TO:	CHAIR AND MEMBERS PLANNING & ENVIRONMENT COMMITTEE	
FROM:	JOHN M. FLEMING MANAGING DIRECTOR, PLANNING AND CITY PLANNER	
SUBJECT:	T: APPLICATION BY: VIREO HEALTH FACILITY LTD.  1444 ADELAIDE STREET NORTH PUBLIC PARTICIPATION MEETING ON MARCH 25, 2014

That, on the recommendation of the Managing Director, Planning and City Planner, the following actions be taken with respect to the application of Vireo Health Facility Ltd relating to a property located at 1444 Adelaide Street North:

Figure 1 – Conceptual Site Plan as Originally Submitted

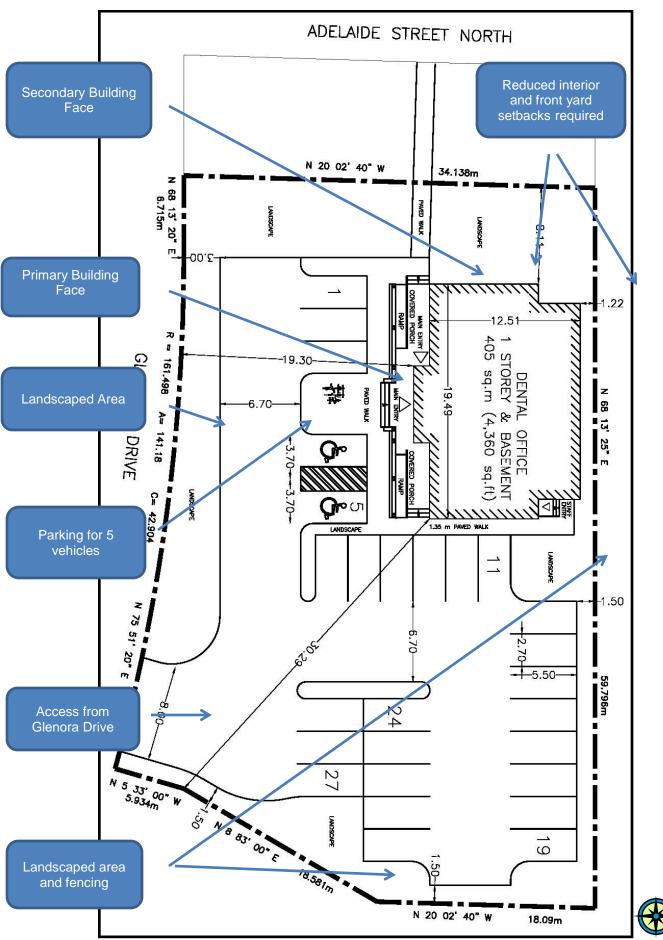
- If the trees do not remain, ensure that the proposed building moves to the south-west corner to properly address Adelaide Street North and Glenora Drive;
- Should it remain in its current location, consider rotating the building 90 degrees to have the primary façade address the primary street;
- Consider continuing the porch around on the Adelaide Street North elevation in response to the corner condition;
- The raised entrance compromises accessibility to the building; and,
- Consider permeable concrete and asphalt for storm water infiltration.

As originally submitted the development proposal anticipated a primary building face oriented towards Glenora Drive and a secondary building face oriented towards Adelaide Street North. The existing vehicular entrances from Adelaide Street North would be closed. Access to the site was to be limited to the existing driveway on Glenora Drive. Parking was to be located in the exterior side yard and the rear yard. Landscaping and privacy fencing were proposed to screen the parking area from residential uses to the east and south (see Figure 1).

Figure 2 - Revised Site Plan Based on the Comments of the UDPRP

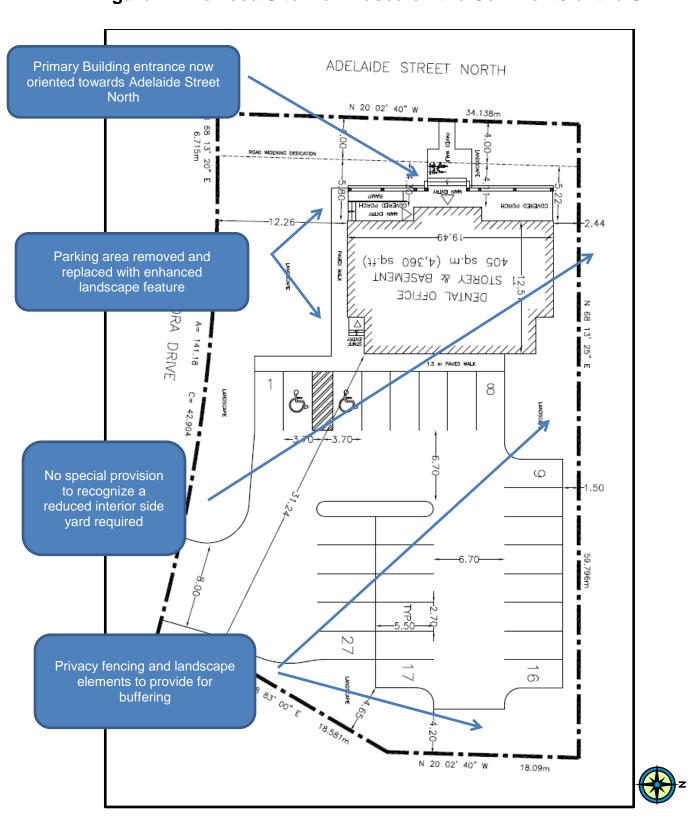
- The relocation of the building to front onto Adelaide Street North is consistent with Official Plan Urban Design policies regarding street orientation of buildings. This revision has also allowed for all of the parking to be accommodated in the back of the property away from the prominent street corner;

- The primary entrance to the building should be oriented towards Adelaide Street North and a paved walkway be provided from the building to the public sidewalk in order to provide direct and convenient access. The Adelaide Street North façade should appear as the primary façade and the Glenora Drive elevation should have a similar level of detail and appear as a secondary façade. A reduction in the amount of glazing on the south façade is acceptable to mitigate the effects of too much sun entering certain rooms of the building. The windows, however, should be more balanced of their location should respond to articulation on the building façade;

- The proposed building should have a tall urban character to frame the public realm and contribute positively to the pedestrian environment along Adelaide Street North. Concerns with the fit and character of the building architecture will be worked out at the Site Plan Approval stage; and,

- A tree protection report will be provided at the Site Plan application stage, and the applicant has indicated a desire to preserve as many trees as possible during construction.

In response to the comments of the UDPRP the applicant submitted a revised concept plan and elevations that served to "re-orient" the building by 90 degrees so that the primary building façade is oriented towards Adelaide Street North (see Figure 2). The revised plan would also allow the associated parking area to be completely contained to the rear of the proposed building so that a larger landscaped area could be provided adjacent to the mature trees located along the southerly property line. The re-orientation of the building further served to eliminate the need for a special provision to provide for a reduced interior (north) side yard. A special provision to provide for a reduced front yard setback from the 19.5 metre Adelaide Street North road allowance would continue to be required.

revised concept plan enlarges the landscaped area on the south side of the property further protecting a stand of existing trees the community wishes to see maintained. The revised concept plan also provides for privacy fencing and landscaping elements along the northern and eastern limits of the property to address the issues of noise and exhaust raised by local residents.

### Appendix "C" - Conceptual Site Plan

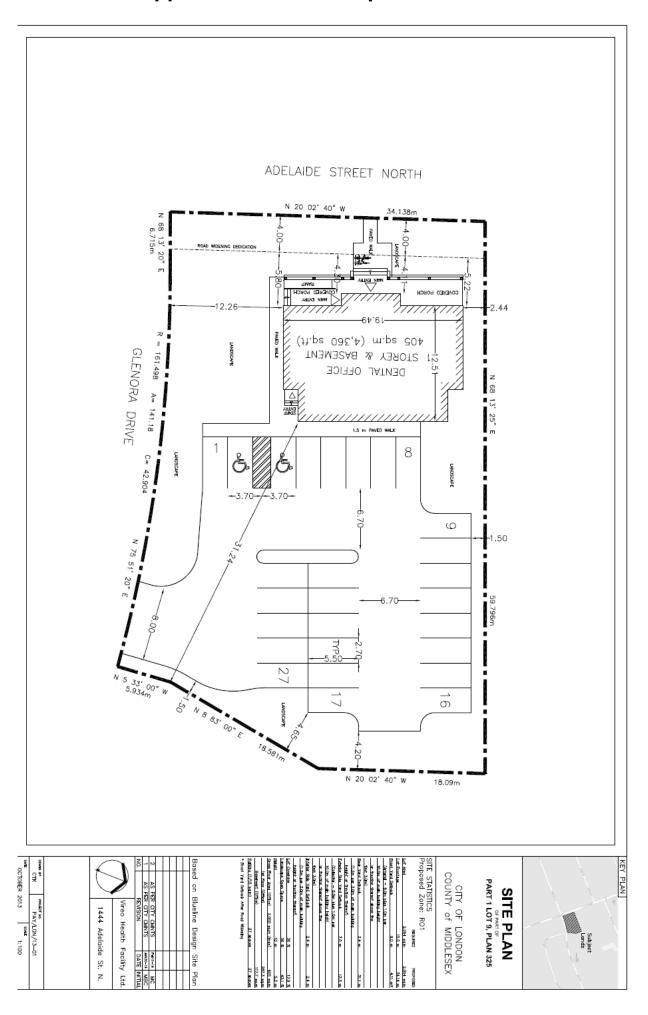
- (c) The Site Plan Approval Authority **BE REQUESTED** to implement the following items through the site plan process:
  - The relocation of the building to front onto Adelaide Street North to create a street wall which is oriented toward the corridor while parking is to be accommodated in the back of the property away from the prominent street corner;

- ii) The existing trees located at the southwest corner of the property should be retained to facilitate a landscaped buffer at the gateway of the residential neighbourhood along Glenora Drive;

- iii) Parking areas should be screened from Glenora Drive and Adelaide Street North with enhanced landscaping to create a soft interface between this office use and the existing residential neighbourhood and the location of the driveway off of Glenora Drive to support safe circulation of pedestrian and vehicular traffic;

- iv) A paved walkway should be provided from the building to the public sidewalk in order to provide direct and convenient access. The Adelaide Street North façade should appear as the primary façade and the Glenora Drive elevation should have a similar level of detail and appear as a secondary façade in order to facilitate the appropriate building orientation. A reduction in the amount of glazing on the south façade is acceptable to mitigate the effects of too much sun entering certain rooms of the building. The windows, however, should be more balanced or their location should respond to articulation on the building façade;

# Appendix "C" - Conceptual Elevations (West and South Elevations)

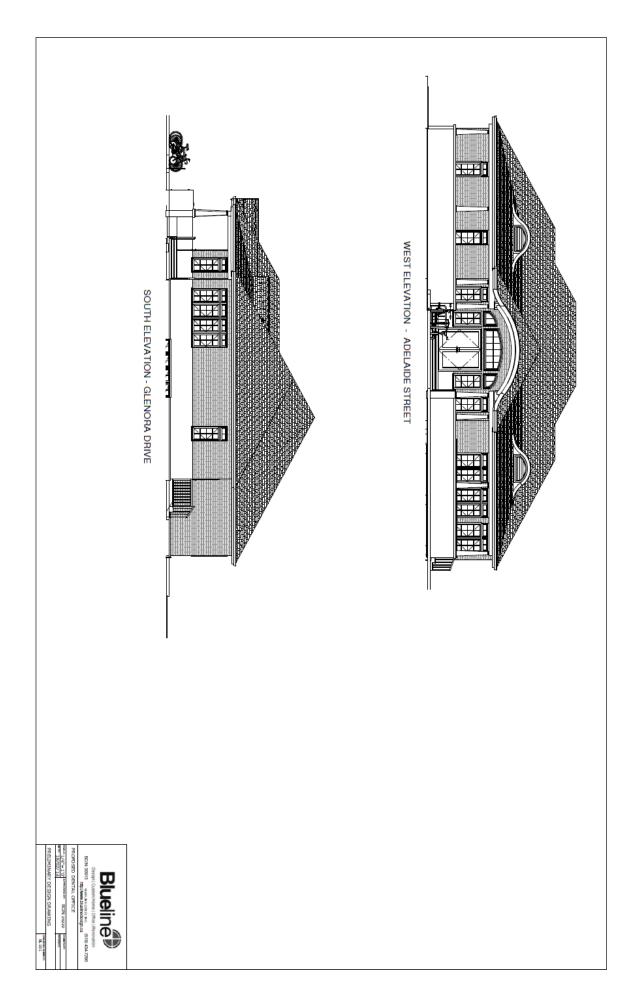
- v) The proposed building should have a tall urban character to frame the public realm and contribute positively to the pedestrian environment along Adelaide Street North.
- vi) Ensure that the siting/construction of the proposed office building is consistent with the conceptual site plan and elevations included as Appendix "C" to this report.
